**CITY OF SAVANNAH
MID-CITY
CERTIFICATE OF APPROPRIATENESS**

STAFF DECISION

FILE NO.: 18-006572-COA

PROPERTY ADDRESS: 410 East 37th Street

PROPOSED SITE PLAN

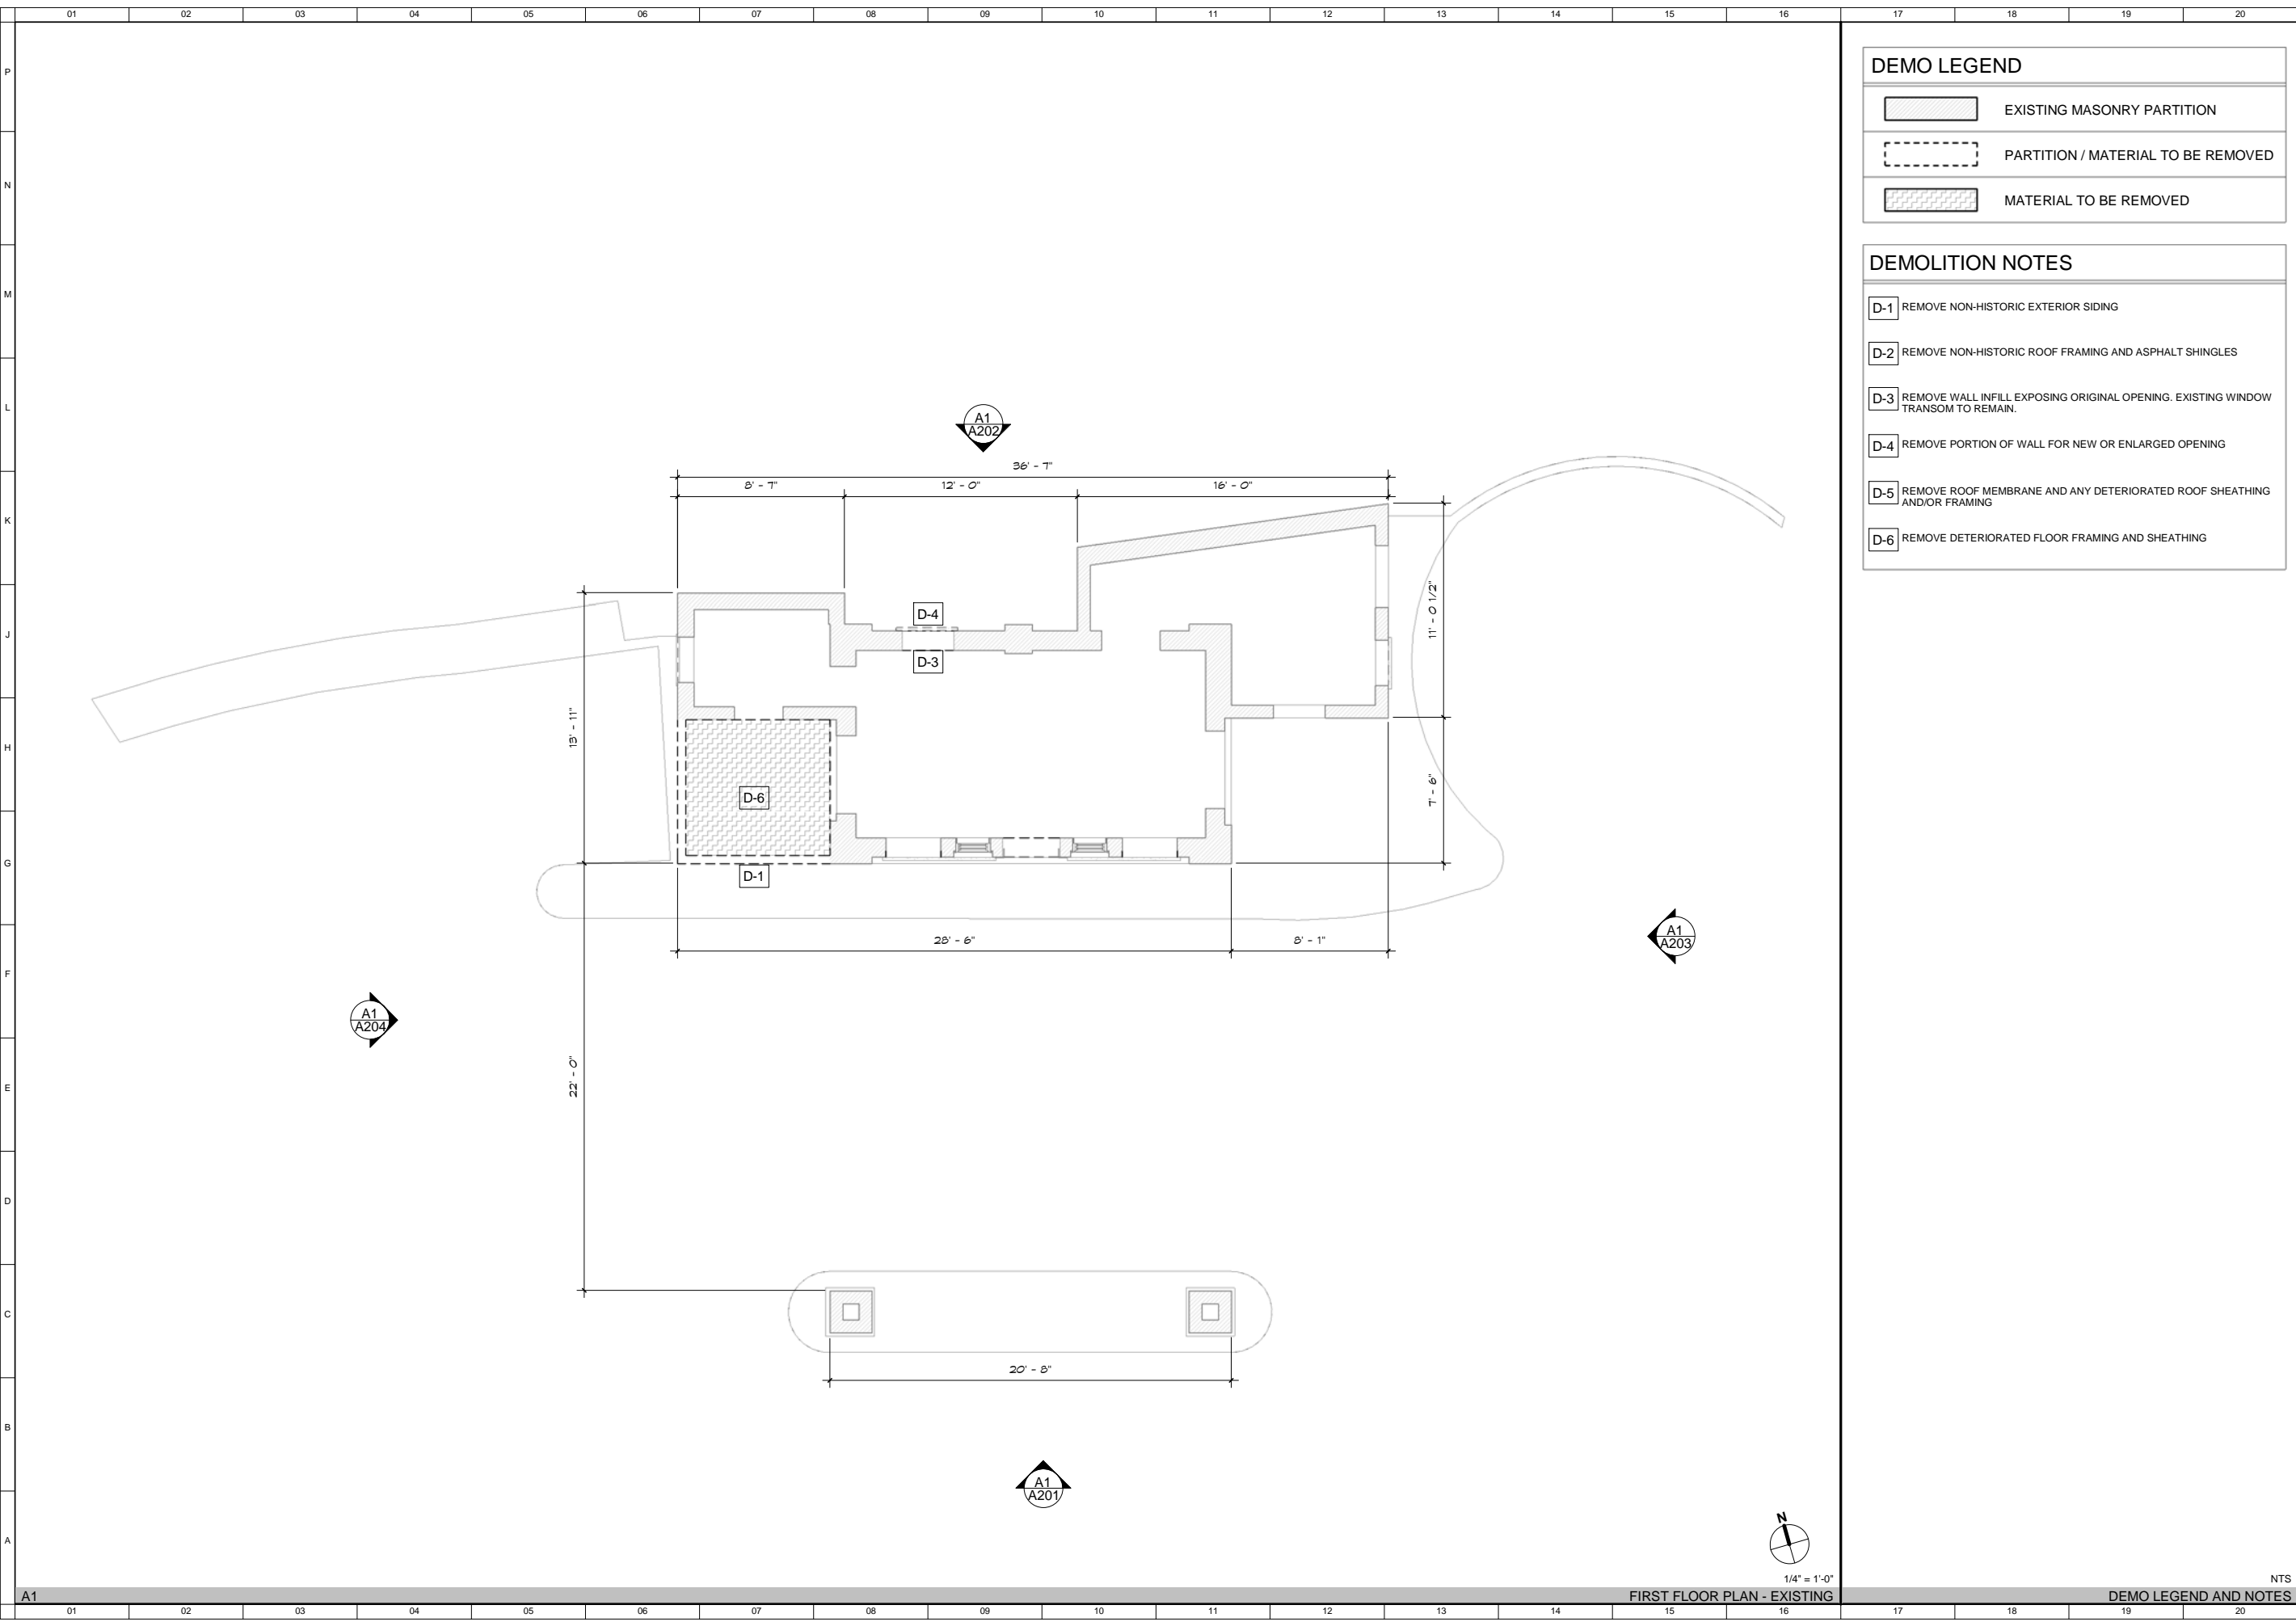
The standard is not met. The pre-fabricated walk-in cooler and addition do not provide a minimum 10-foot rear yard setback. The addition appears to provide approximately 8-feet from the rear yard and the cooler appears to provide approximately 1-foot from the rear yard.

Staff recommends approval of the requested variances. The existing lot, with the principal nonresidential building, has an unusual triangular shape due to its close proximity to a railroad track to the northwest. The existing principal building does not meet the required 10-foot rear yard setback, nor will the proposed extension to the addition or proposed pre-fab walk-in cooler. However, the additions are visually compatible and meet the intent of the Ordinance.

1/4" = 1'-0"
WEST ELEVATION

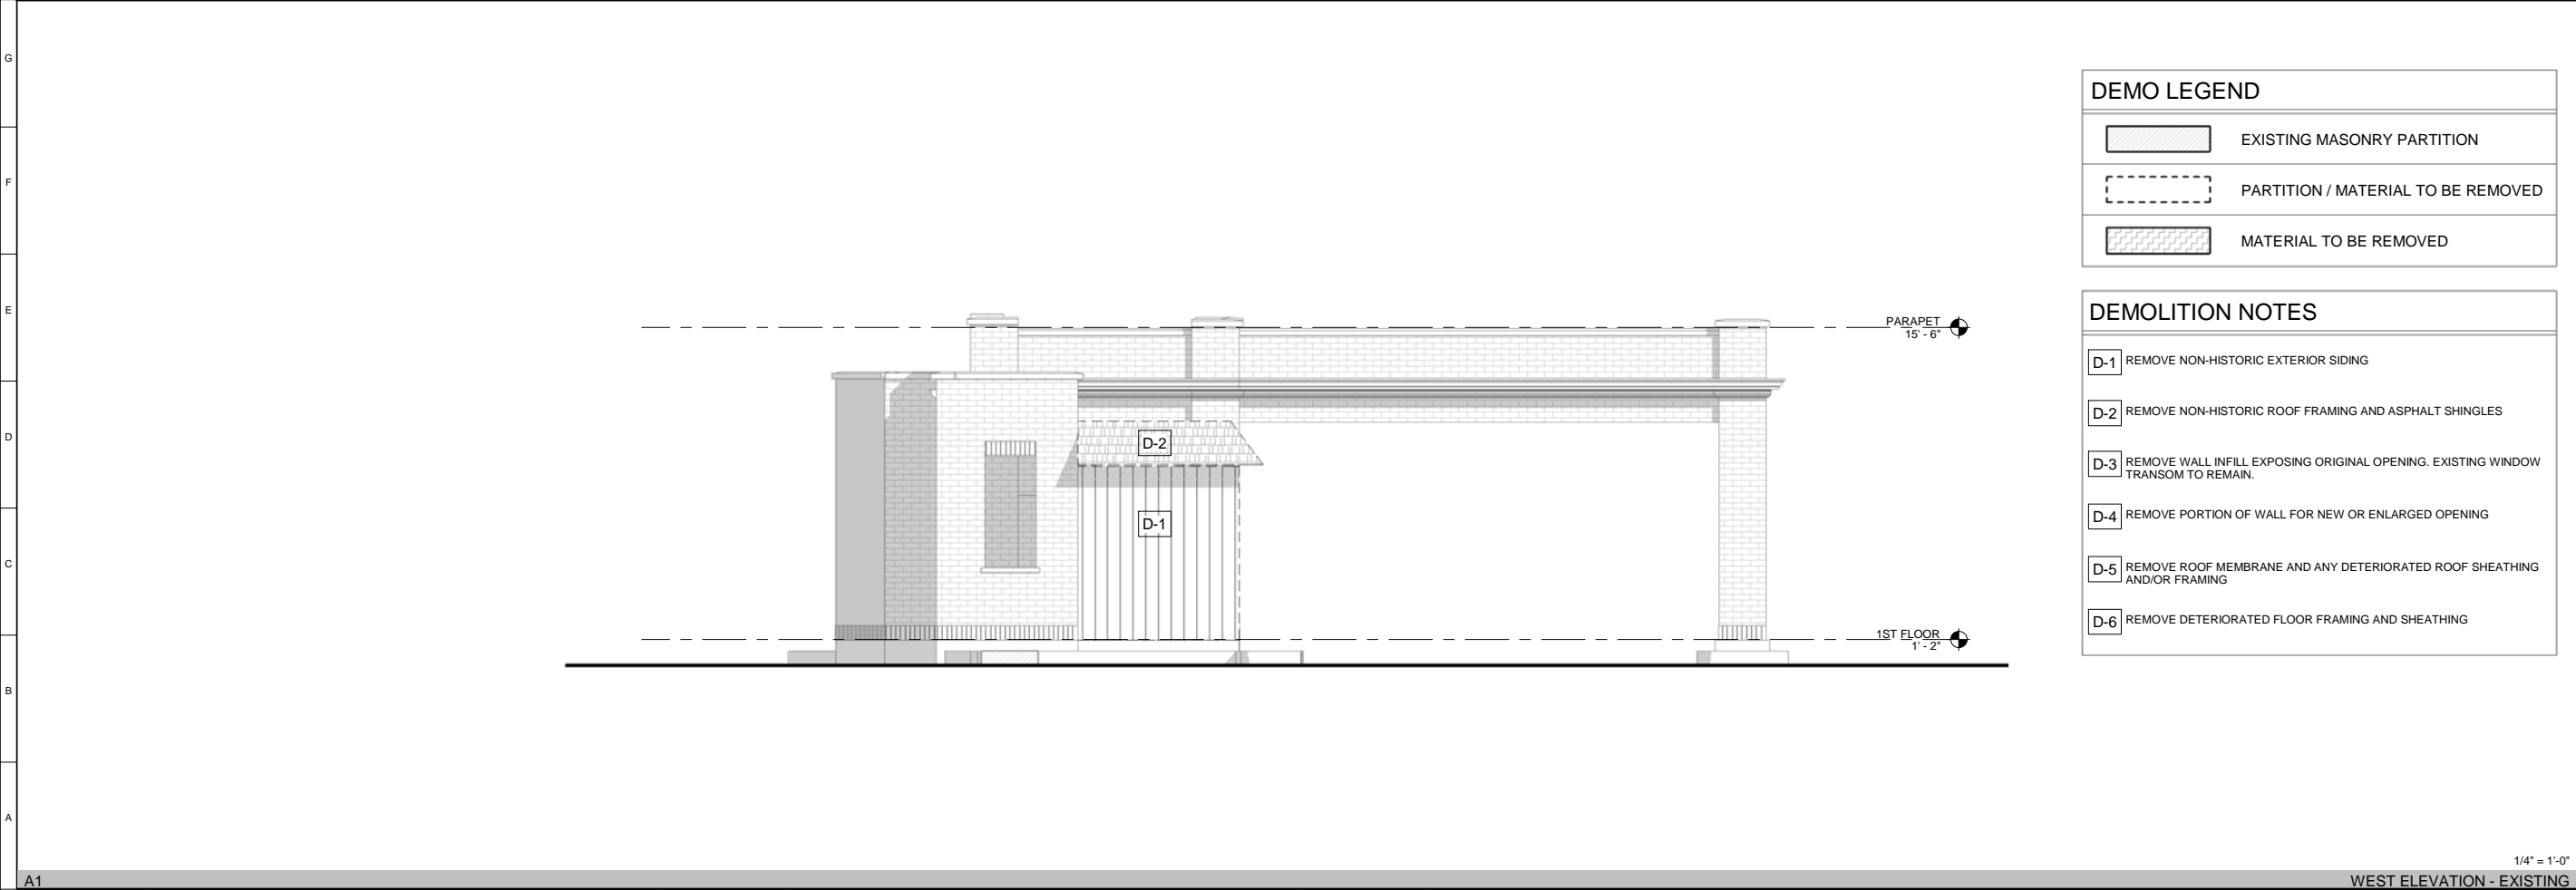
The standards are met. The corner parcel fronts both Price and 37th Street. The east and west building elevations fronting these streets will feature single entry doors as part of the proposed infill storefront system located within the existing port cochere. The doors will be constructed of clear anodized aluminum. The missing doors on the historic building will be replaced with 2-panel wood doors and one wood and glass replacement door at the building's south elevation.
